Inspection Report for North Sturbridge Road Solar Facility

NPDES ID No.: MAR10031G

Inspection Date: 11/19/2021

**FIGURE 1:
SWPPP
INSPECTION
SKETCH
11/19/2021**

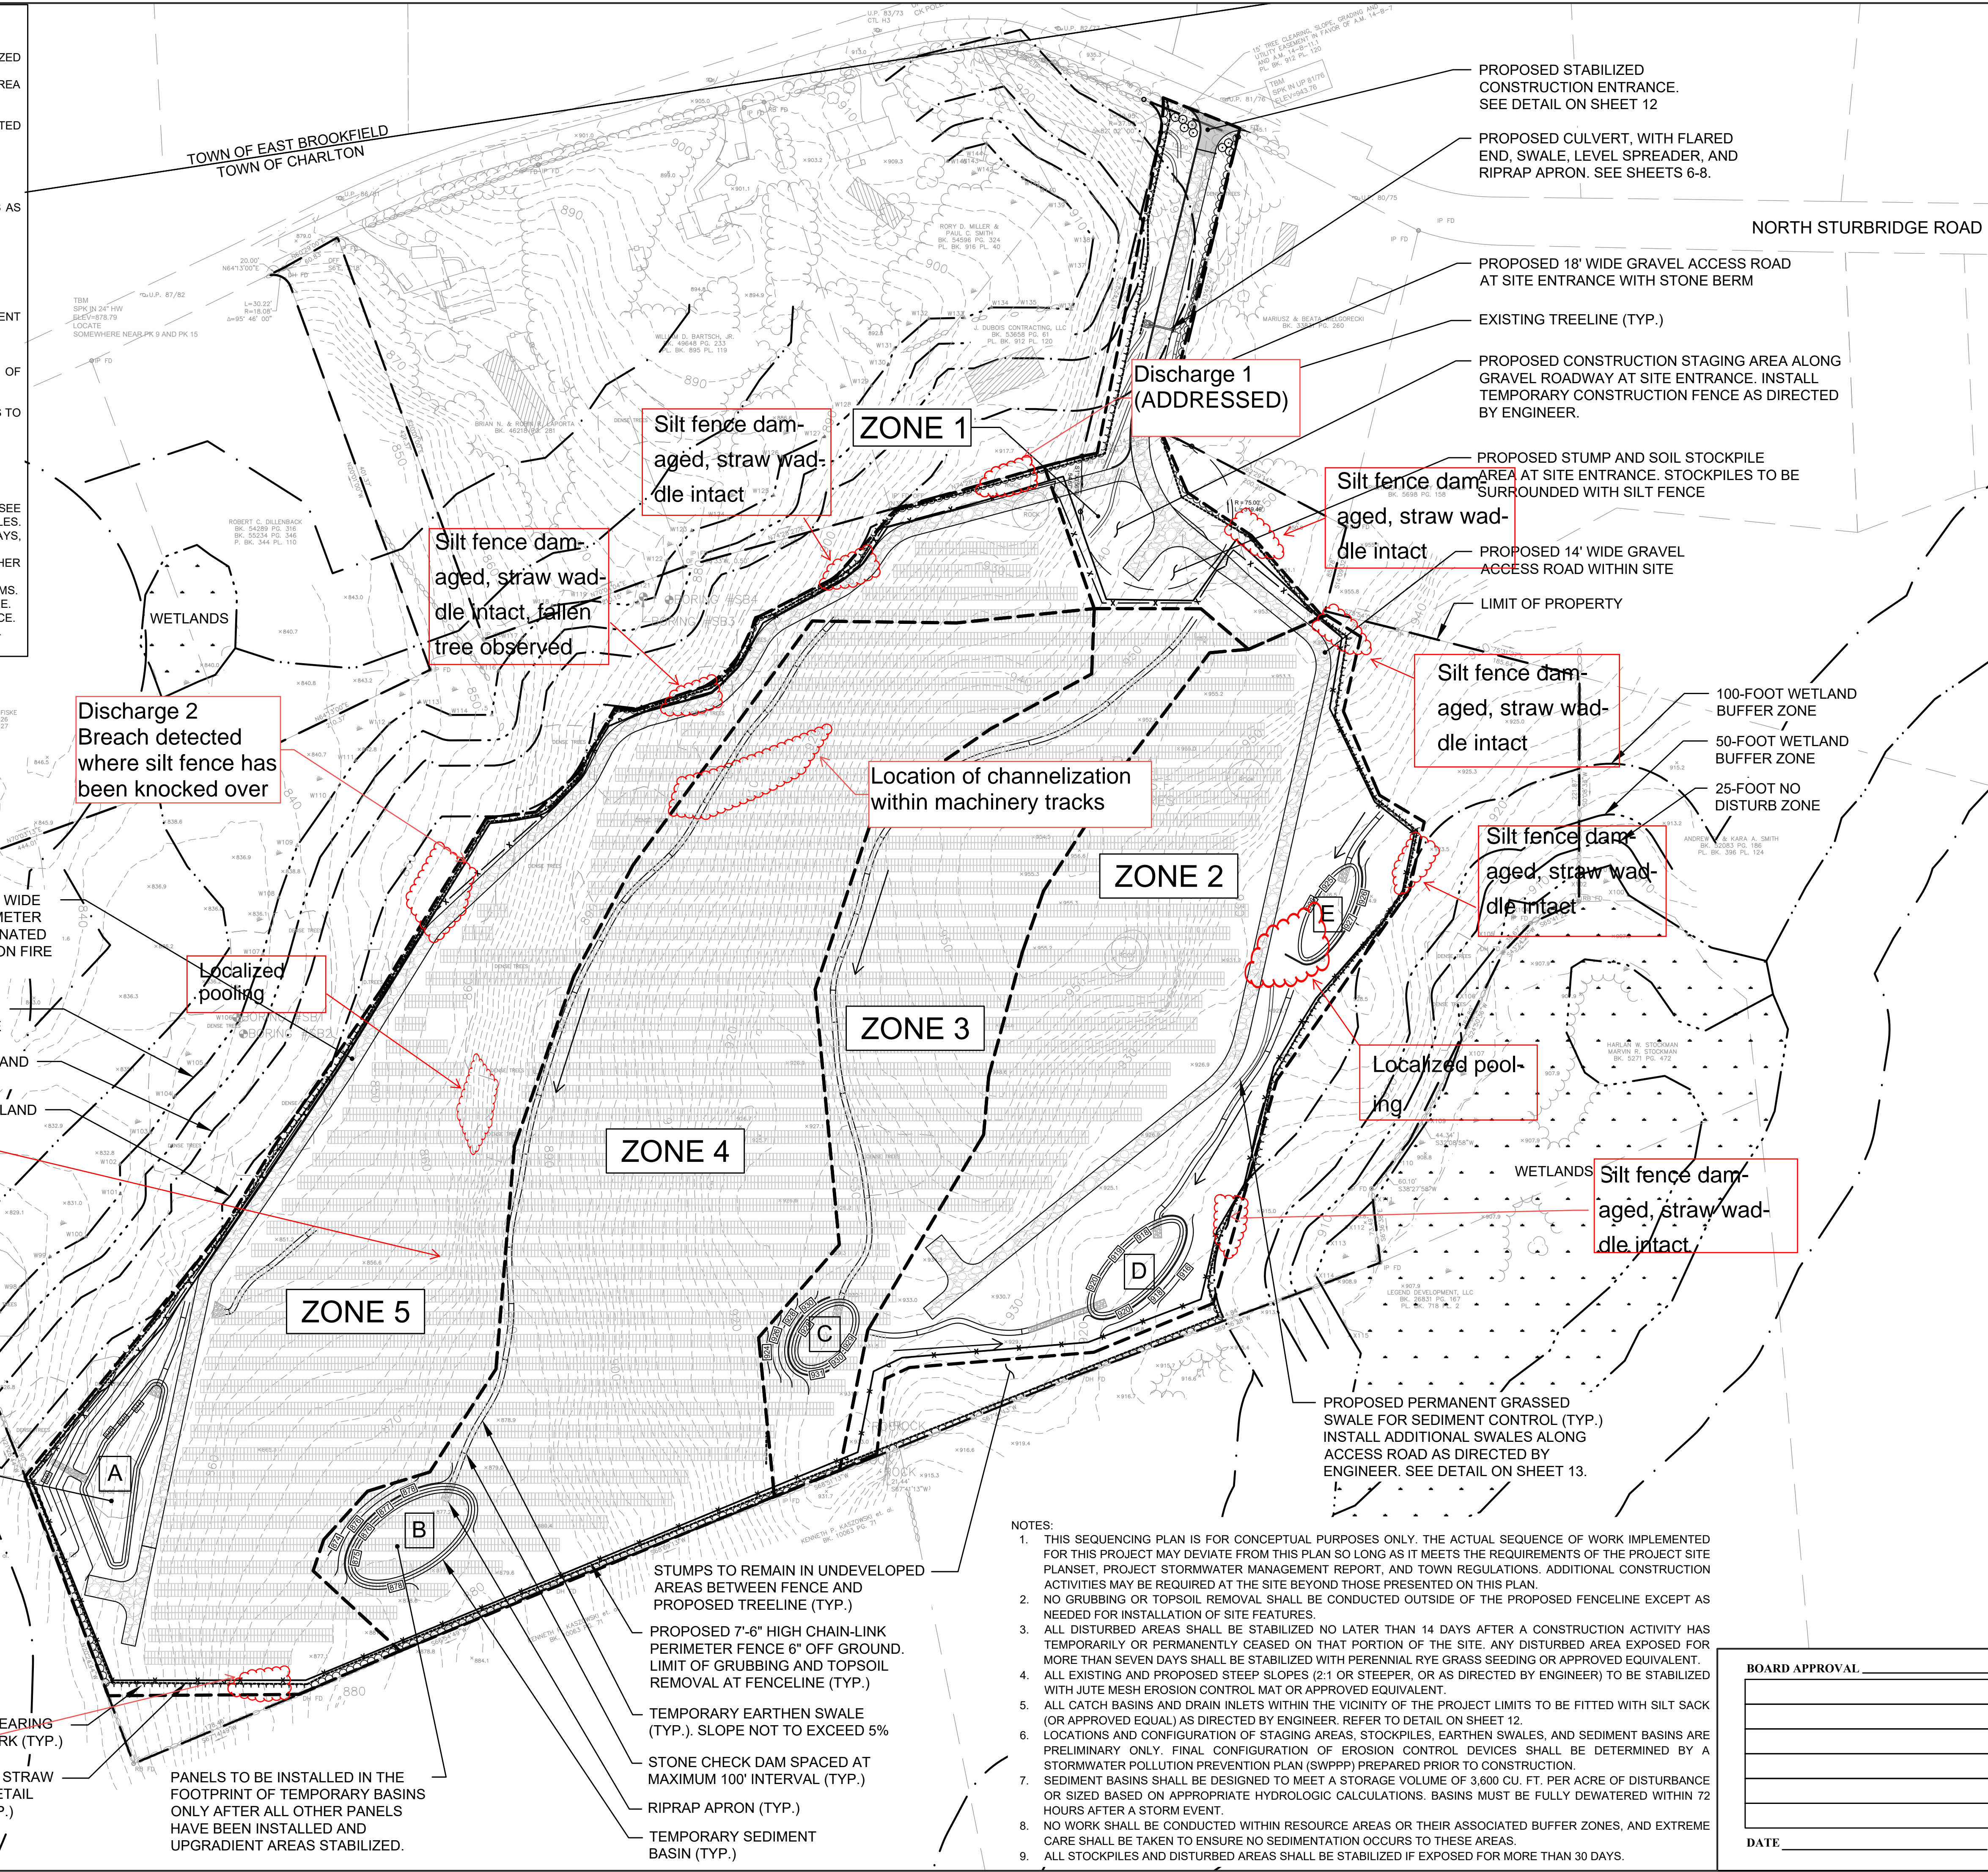
Type/Location of E&S Control	Maintenance Needed?*			
1. Silt Fence and Straw Wattles	Yes (As of 9/2/2021)	No	9/2/2021	<p>A breach was observed at Discharge 2. Although the double row of straw bales is intact, silt fence was observed to be knocked over and signs of stormwater flow were detected in the area beyond the fence.</p> <p>A minor tear was identified in a section of silt fence on the southern side of the Site with no erosion observed.</p> <p>Minor degradation of a straw wattle was observed on the southeastern side of the Site; no erosion was observed but pools of water were found to be forming behind the straw wattle.</p>

2. Stabilized Construction Entrance (Site Entrance – Access Road)	No (As of 9/2/2021)	No		<p>A tree was knocked over and laying on the silt fence on the on the northwestern portion of the site in Zone 5.</p> <p>Hydroseed was applied to exposed soil in this area and continues to germinate, some grass seedlings are now observed.</p>

3. Stump and Soil Stockpile Area	No (As of 7/22/2021)	No	10/29/2021	<p>Minor tears were observed in the silt fence along the eastern boundaries of the Site, due to staples becoming dislodged from wooden stakes. The straw wattles are still intact.</p>

2. Informal access road along northern portion of the Site	Straw mulch or hydroseed	<input type="checkbox"/> Yes [Enter date] <input checked="" type="checkbox"/> No	Erosion channels are beginning to form within upgradient portions of the informal access road (Figure 1). The contractor indicated that stabilization by smoothing out soils and seeding or spreading mulch would occur on 7/30/2021. Stabilization of this area has not been initiated. After inspection of the area on 8/24/2021, it was determined that

Discharge Location	Observations
<p>Discharge 1</p>	<p>Describe the discharge: Breach in silt fence allowed runoff to bypass erosion controls.</p> <p>At points of discharge and the channels and banks of surface waters in the immediate vicinity, are there any visible signs of erosion and/or sediment accumulation that can be attributed to your discharge? <input checked="" type="checkbox"/> Yes <input type="checkbox"/> No</p> <p>If yes, describe what you see, specify the location(s) where these conditions were found, and indicate whether modification, maintenance, or corrective action is needed to resolve the issue: Small areas of bare soil observed in area immediately beyond perimeter controls. Repairs to erosion controls and re-seeding of damaged areas is required.</p>
